Heaton Primary Accessibility Action Plan April 2023

4.1 - ACTION TABLE

13.11

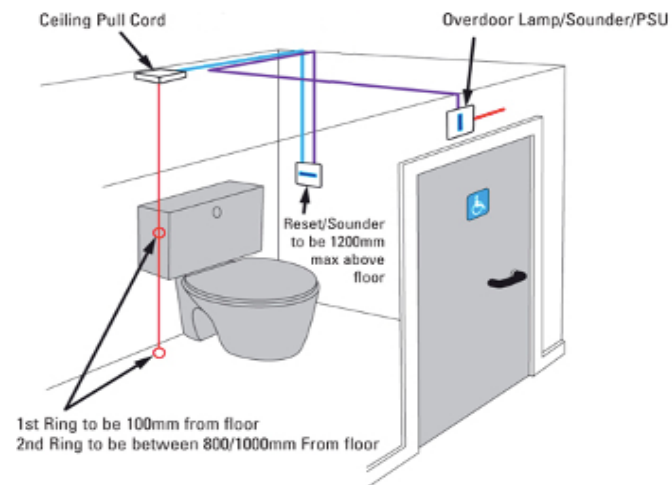
The cord alarm was marginally high from ground floor level in facility 270.

The years 5 and 6 facility featured a cord alarm that was tucked behind a pipe, high from ground floor level.

If a cord alarm is not within a suitable distance from ground floor level, a distress call may go unnoticed.

Implement a management procedure to ensure that cord alarms are always kept loose and not tied up.

According to BS8300 - An emergency assistance pull cord should be sited so that it can be operated from the WC and from an adjacent floor area. The emergency assistance pull cord, coloured red, should be provided with two red bangles of 50 mm diameter, one set at a height between 800 mm and 1000 mm and the other set at 100 mm above floor level.

15.3

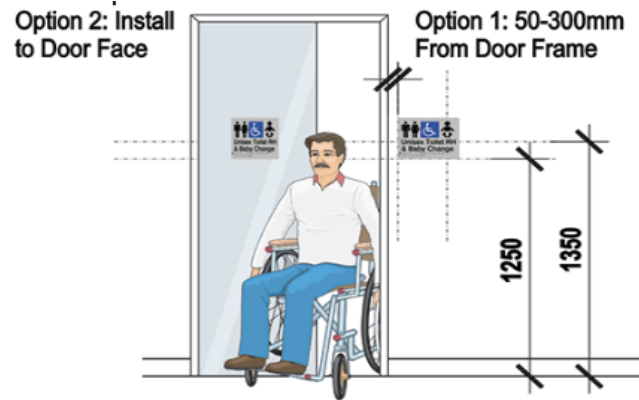
Some WC facilities were suitably signed with pictorial information.

The signage on facility 42 was slightly damaged.

The Hygiene Room 270 was not suitably signed for its purpose.

The WC facility 171 in years 5 and 6 was not suitably signposted.

The appropriate toilet signage should be provided. As well as signage on the toilet doors, there should also be signs indicating where the accessible WCs are located.

BS8300 states - Information and direction signs should be provided at each point where they are required, e.g. at junctions of circulation routes, at key locations such as doorways and reception points, at facilities such as telephones and toilets, and in rooms, spaces and counters. The colour, design and typeface of signs should be consistent throughout a building.

All accessible WC door signage should ideally be accessible to all disabled people with Braille and embossed lettering preferred.

3.1

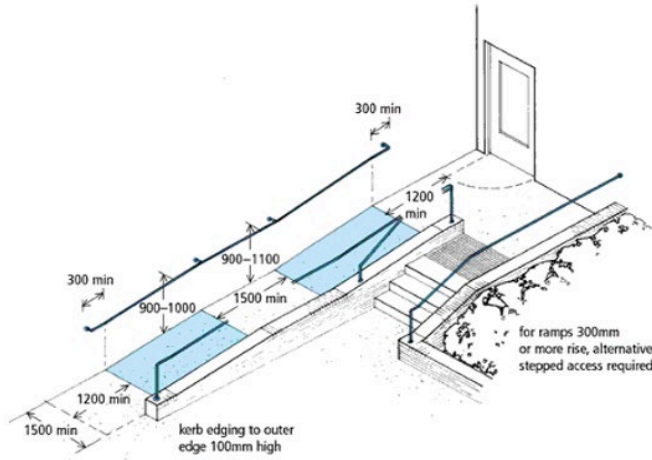
The ramps leading towards the key stage two playground, from both the key stage one and key stage two classrooms were long with no level landings. Contrast was not provided to these ramps to indicate a change in gradient.

The ramp should be subject to remedial works to reduce the gradient to a reasonable slope that can comply with BS8300 and ADM-2:1.26 requirements.

Any permanent ramp must be a maximum 1:12 over a maximum going of 2m, it should be a minimum 1.2m wide and feature 1.2m landings at head and foot, handrails to both sides and a contrasted sloped surface.

Colour contrast should be added to the surface of the ramps.

According to BS8300 - The surface of a ramp should contrast visually with the landings and the edge protection so that its presence is discernible by people who are blind or partially sighted.

4.1

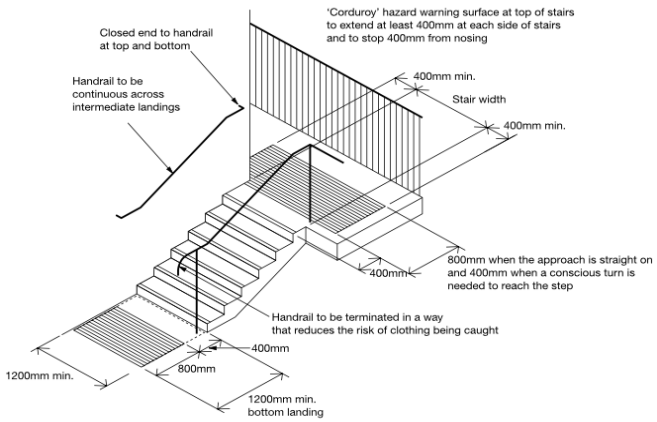
The steps leading towards the key stage two playground featured tactile paving.
 The steps near to room 161 and those leading near the main entrance, did not feature tactile paving to provide warning of the first and final step.

Install tactile paving to the top of the external steps throughout the site.
 BS8300 - To give advance warning of a step, tactile paving with a corduroy hazard warning surface should be provided at the top and bottom of each flight, excluding intermediate landings with continuous handrails. Where the approach to the stair is wider than the flight, the tactile surface should extend beyond the line of each edge of the flight.
